CONDITIONS OF APPROVAL:

Open Issues: 28

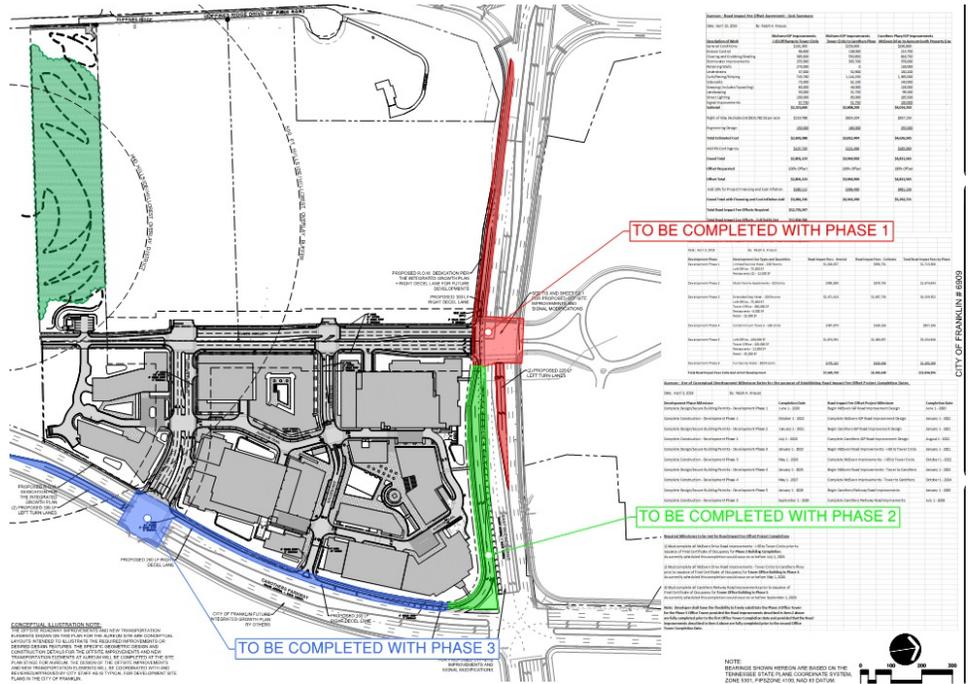
Additional offsite improvements include the following:

- **Prior to the certificate of occupancy** for the first phase office building the developer shall widen the I-65 northbound exit ramp to provide two (2) right turn lanes from I-65 North to East McEwen Drive. This includes any signal modifications necessary to accommodate the additional turn lane.
- **Prior to 50% build out** of the Aureum development, the construction of the East McEwen Drive IGP improvements shall be completed to the Carothers Parkway intersection.
 - Widen East McEwen Drive to provide three (3) travel lanes for eastbound through movements.
 - Widen the eastbound approach of East McEwen Drive to provide two (2) right turn lanes from eastbound East McEwen Drive to southbound Carothers Parkway.

The applicant shall meet with Staff to discuss what may qualify for an Impact Fee Offset Agreement. It is recommended that the applicant produce higher level drawings for estimating purposes as soon as possible in order to reduce delays.

Per recent conversations with City and TDOT staff, it's understood that the I-65 ramp improvements will not be required with the Aureum development. Detailed Impact Fee Offset charts are being included within the PUD to identify full cost breakdown for the road improvements, an itemized breakdown of impact fees collected for each phase, and a conceptual schedule anticipated for each development phase with a conceptual schedule for each Road Impact Fee Offset project and completion. A summary of milestone requirements for completion of roadway improvements is also provided.

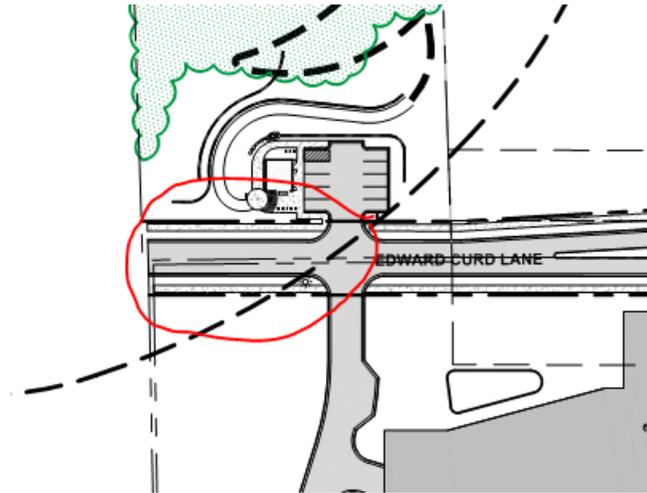
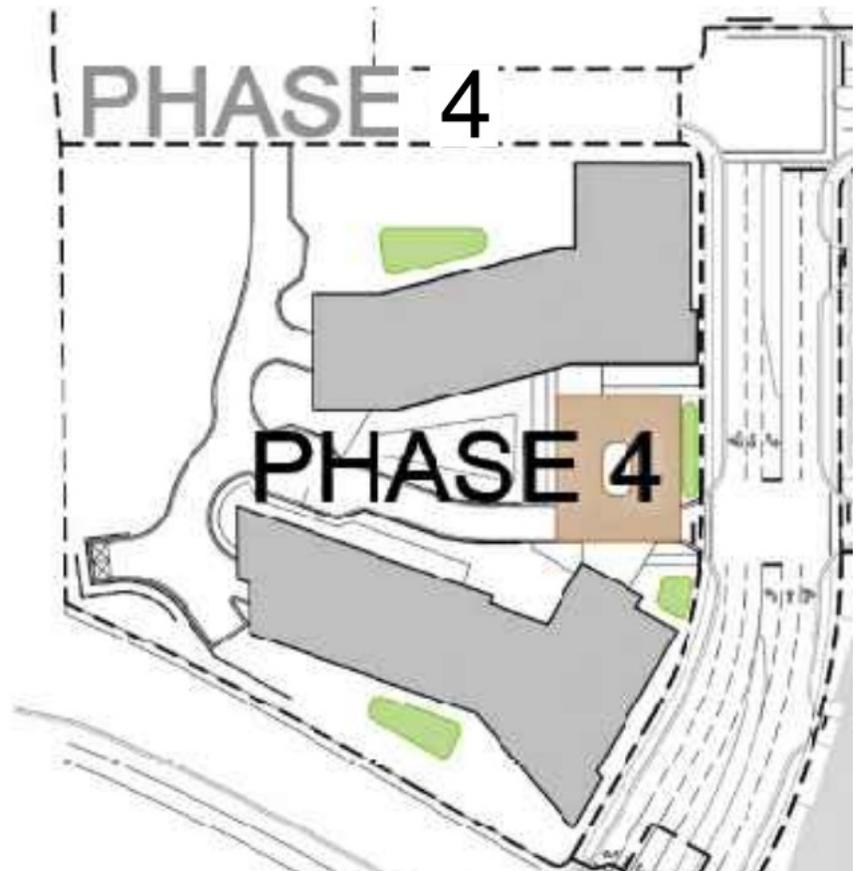
jimmy.wiseman@franklinton.gov *This comment was partially addressed.*

Design teams from the Huffines PUD and Aureum PUD shall meet with City Staff on Wednesday 4-17-19 to coordinate the finalized location of the southern roadway connection.

The development plan currently shows this as part of Phase 6. This connection shall be made with the development of the adjacent parcel identified as Phase 4.

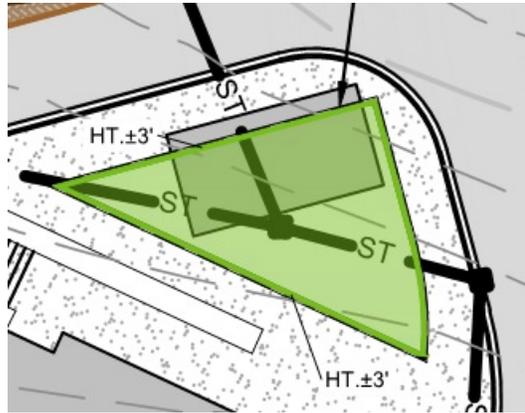
Is the jewel box building intended to be within (above?) the water quality area shown?

lance.fitto@franklinton.gov Applicant shall indicate the footprints of the water quality area and the jewel box building as separate on the development plan. The location of green infrastructure practices beneath structures is not an approved practice per the BMP manual. At Site Plan stage, it shall be demonstrated that all portions of the proposed water quality area are accessible with equipment as may be necessary for both installation and long term maintenance. Encroachment of structures over GIP's to the degree presented is not acceptable. Location of any portion of proposed structures over GIP's will be examined critically at Site Plan stage and any permitted encroachments shall be seen as exceptions to the non-encroaching scenario presented on the Development Plan, not vice versa.

sbernick@ragansmith.com At this time, we are expecting the jewel box to be elevated above a portion of the water quality area as a design feature to engage and activate the space while not being adhered by the water quality feature. We understand that this is currently not a common practice in the city of Franklin, but do look forward to discussing the details for the proposed improvements with staff during the site plan stage.

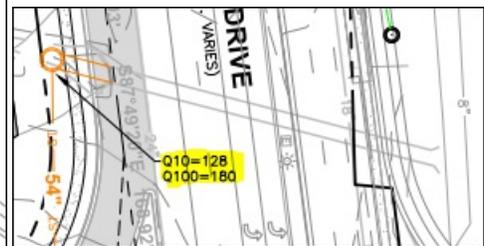
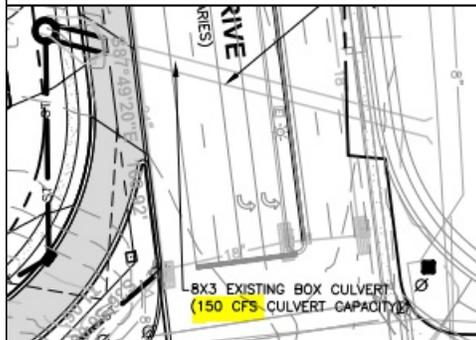
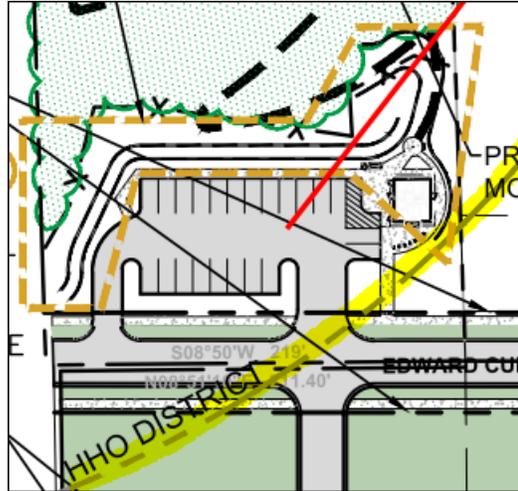
Advisory Comment: During detailed engineering design at the Site Plan Stage, the Applicant will be required to provide analysis for the next two off-site downstream structures, including for the existing culvert below East McEwen Drive. Should the analysis indicate that the existing storm structure(s) do not have capacity to handle flow from the site, the Applicant will be required to replace the structure(s) with appropriately sized infrastructure.

Drainage requirements from the City of Franklin Street Specifications Table 11.1 are copied below, along with screenshots of the latest PUD submittal. It is unclear if the Q10 and Q100 values shown below include flow from East McEwen Drive.

It is the intent of this development to maintain existing stormwater flow paths and outfall locations while providing stormwater detention onsite so that no additional burdens are placed on downstream structures. The development team also is anticipating that due to the fairly new construction of this box culvert, there should not be an expectation of it needing to be modified for existing conditions.

It is understood that additional calculations and analysis will be required at site plan submittals to ensure our proposed improvements can coexist with these existing conditions.

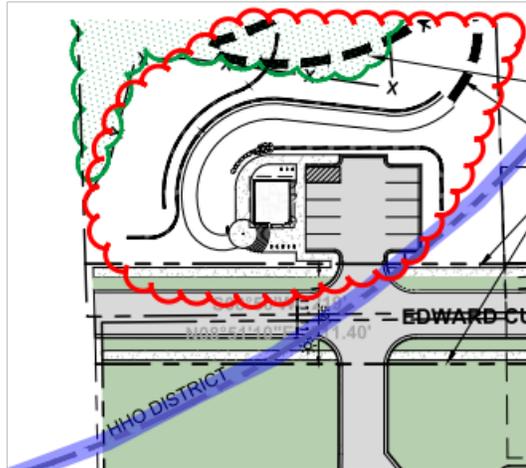
joe.marlo@franklintn.gov Comment not adequately addressed.

Grading activities shown in the HHO are not permitted. Applicant to remove walls and associated elements requiring grading from within the HHO.

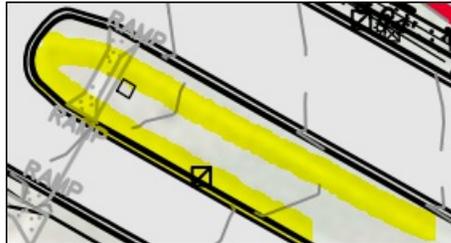
At the site plan stage, all roadway improvements shall be designed in accordance with the appropriate common standards as established by (A) the City of Franklin Transportation and Street Technical Standards, (B) the AASHTO Policy on Geometric Design of Highways and Streets, and (C) the Tennessee Department of Transportation Design Guidelines and Standard Details. Features such as taper lengths, horizontal and vertical geometry, clear zones, guardrail requirements, etc., shall be evaluated in greater detail at the site plan stage and will be required to conform to the accepted standard in order to ensure public safety and well-being, as well as the continued functionality of the existing and proposed street networks.

sbernick@ragansmith.com Understood. It is also understood that any adjustments which do not meet these requirements will be required to be approved by a letter from the director.
[Edited By Scotty Bernick]

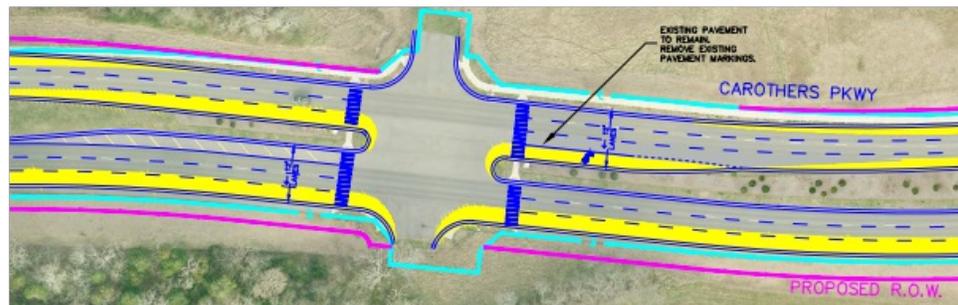
Applicant to revise ROW Dedication along Carothers Parkway to reflect the IGP. At the Carothers Parkway/Ovation Parkway intersection, Applicant to revise median / pavement / striping to accept SB through traffic.
